MEMORANDUM

SUBJECT: Special Use Permit and Site Plan Approval – 440 State Street

DATE: June 4, 2026

Request: Special Use Permit and Site Plan Approval to construct a 544 square-foot (SF) coffee shop with an accessory drive-through and associated site improvements on lands that currently comprise **430 State Street**, Parcel Number 12-03-220.200 and **440 State Street**, Parcel Number 12-03-220.300.

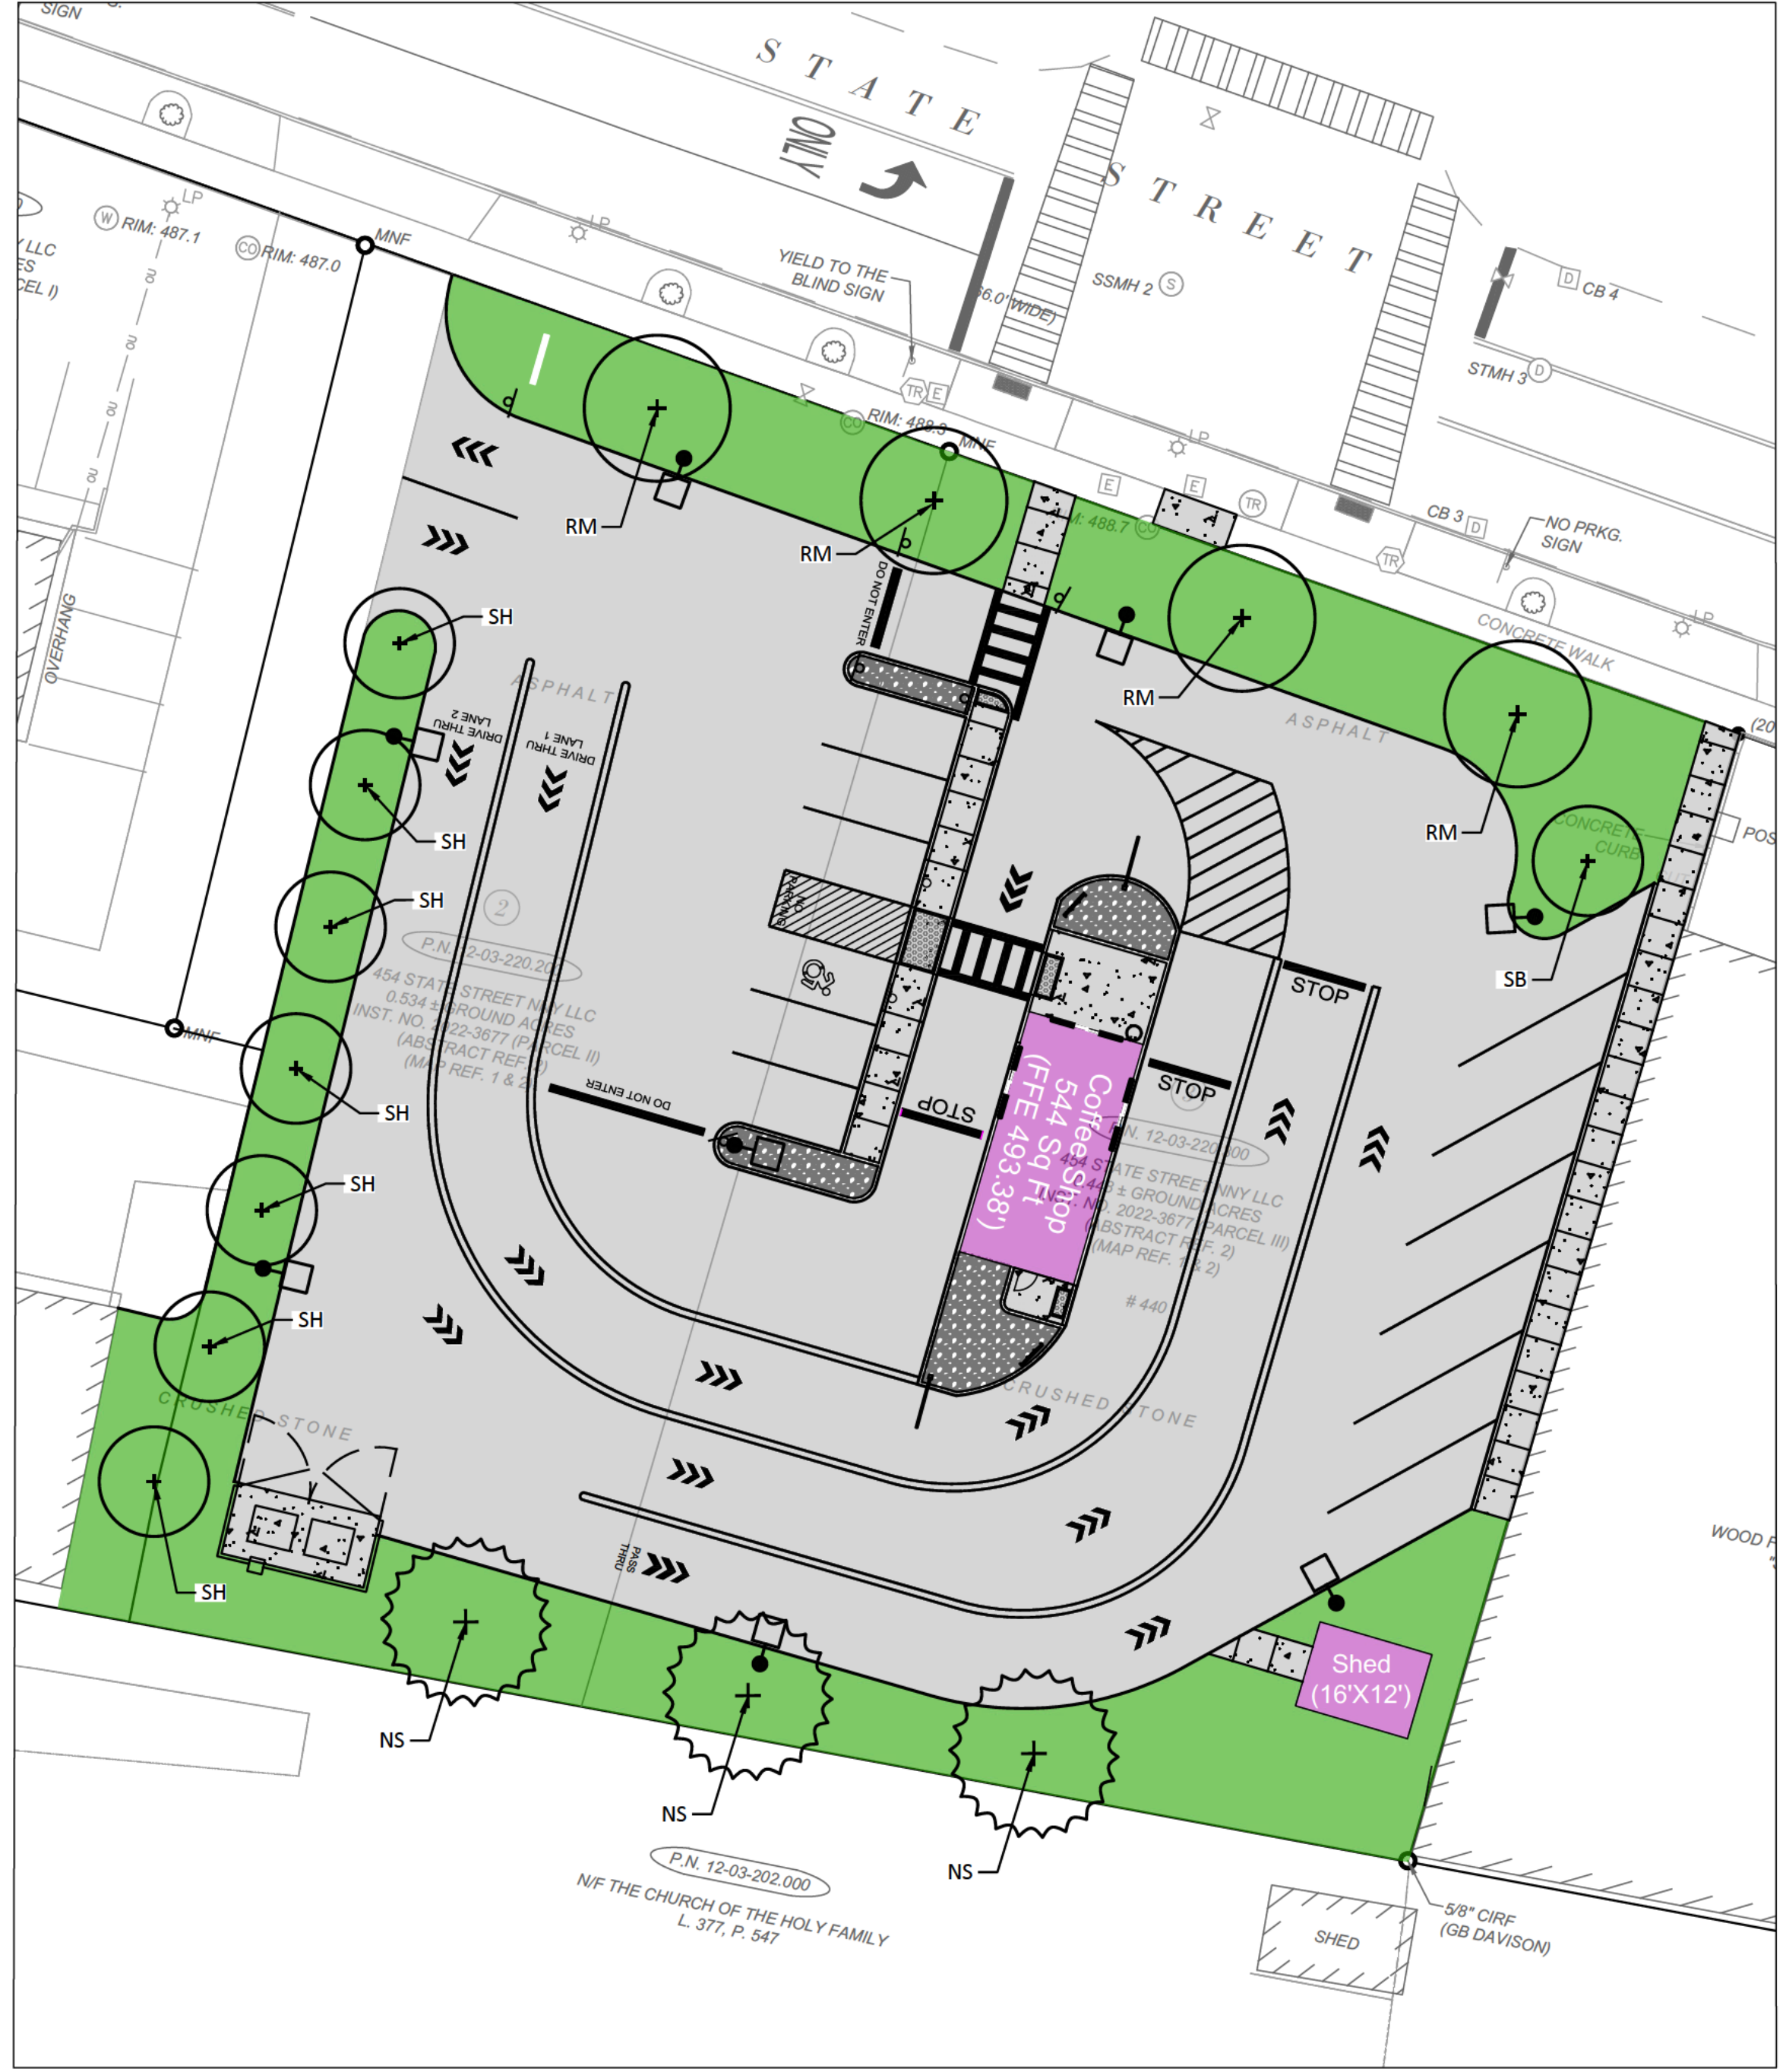
Landscaping: The applicant proposes 15 total trees around the perimeter of the site; 12 deciduous and three (3) evergreen trees. However, the applicant only proposes four species of trees, with one species accounting for seven (7) of the 15 trees. Section §310-83 (B)(1) of the Zoning Ordinance states that no one species of trees may take up more than 15% of the total amount of the proposed tree plantings. The applicant shall identify additional species to increase diversity on the site. Species diversity is important on development sites and within cities because without diversity, the tree canopy and overall landscape can be vulnerable to elimination if pests or diseases attack certain species in the future.

Along the street ROW, Section §310-83 (C)(1) of the Zoning Ordinance requires the applicant to provide one large deciduous tree every 40 linear feet or one small to medium deciduous tree every 20 linear feet. The site has 210 feet of frontage on State Street, and the applicant proposes four large deciduous trees.

Dividing $210 \div 4 = 52.5$, yielding an average of 52.5 feet between trees. However, the presence of a sign and the perpendicular sidewalk leading into the site make planting impractical along the full frontage. The proposal meets the intent of the Zoning Ordinance in good faith. The position of the Red Maple trees should allow for adequate growing space between them and the large-maturing street trees in the ROW on State Street. Before planting, the owner should contact the City Forester to have the positions approved.

Section §310-83 (F) of the Zoning Ordinance requires the applicant to provide one large deciduous tree every 40 linear feet or one small to medium deciduous tree every 20 linear feet or one large coniferous tree every 20 linear feet around the perimeter of parking lots. The applicant proposes three large coniferous trees along the rear property line, but at 42-foot intervals rather than 20-foot intervals. The applicant must either meet the spacing requirement for coniferous trees or alternatively plant large deciduous trees if the wider spacing is desired.

If additional coniferous trees are added along the rear property line, this could be an opportunity to add species diversity. White Spruce or Colorado Blue Spruce would be good options.

The two Honey locust trees in the back corner of the lot may be too close to the building at the rear of 430 State Street. This could cause additional maintenance for the trees which would be the responsibility of the property owner. The applicant should consider a smaller maturing or upright tree in these positions. This is another opportunity to diversify the planting plan. The applicant should also consider planting an alternating row of Honey locust with American Hornbeam, *Carpinus caroliniana* as an example. The similar mature shape and size of the Hornbeam would maintain the neat appearance of the row while adding diversity.

Not mentioned in the landscape plan is the treatment or preservation of the large Eastern Cottonwood tree at 122 Winthrop Street, along the rear property line. Section 310-83 (I) lays out the incentives to preserve “high quality”. Before excavation, a decision needs to be made with the adjacent property owner whether it will be removed or if it will stay and receive protection and any pruning necessary to give the conifers adequate overhead growing space.

Finally, the proposed tree locations along the rear property line are strategically placed in between the snow storage areas, although there is not much room between the two. If trees become damaged during snow removal activities, the property owner will be responsible for replacing any damaged trees to restore the site to the condition of the approved site plan.

12. The applicant shall revise the landscaping plan to conform to the requirements of Section 310-83 of the Zoning Ordinance.
13. The applicant shall obtain, minimally, each of the following: Building Permit, General City Permit and a Zoning Compliance Certificate.
14. The applicant shall submit a revised set of drawings that satisfies all summary items for approval of the Planning and Engineering Departments, prior to the issuance of any permits.

NORTH ELEVATION
SCALE: 3/8" = 1'-0"

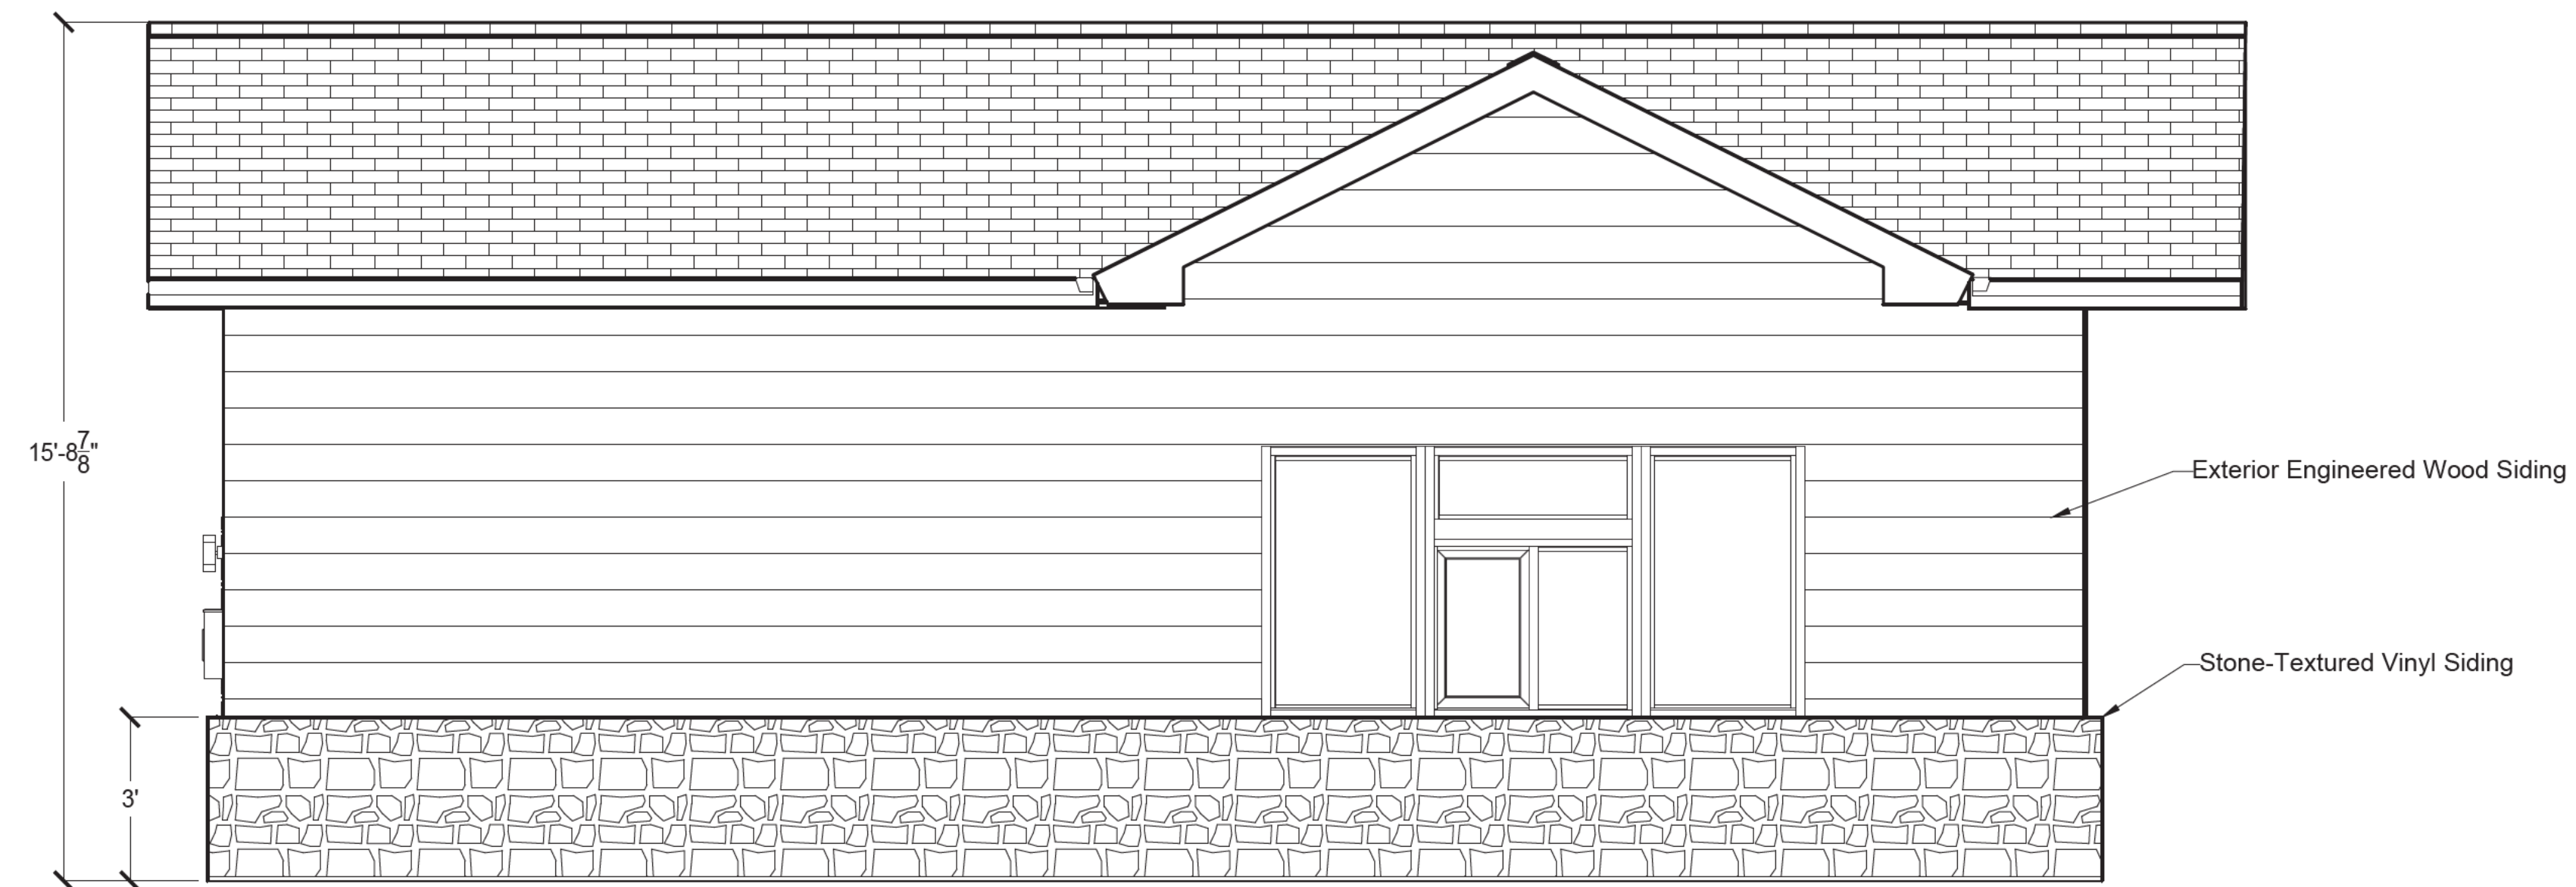
The elevation drawings of the proposed building depict siding above a stone veneer on all facades and small windows. The proposed front (north-facing) window currently measures approximately 50 SF. This window will need to increase in size by approximately 15 SF to conform to the 40 percent ground floor, front façade transparency requirement of the UMU District. Alternatively, the applicant could add sidelight windows and/or a transom window in concert with a larger primary window to meet the aggregate 40 percent requirement.
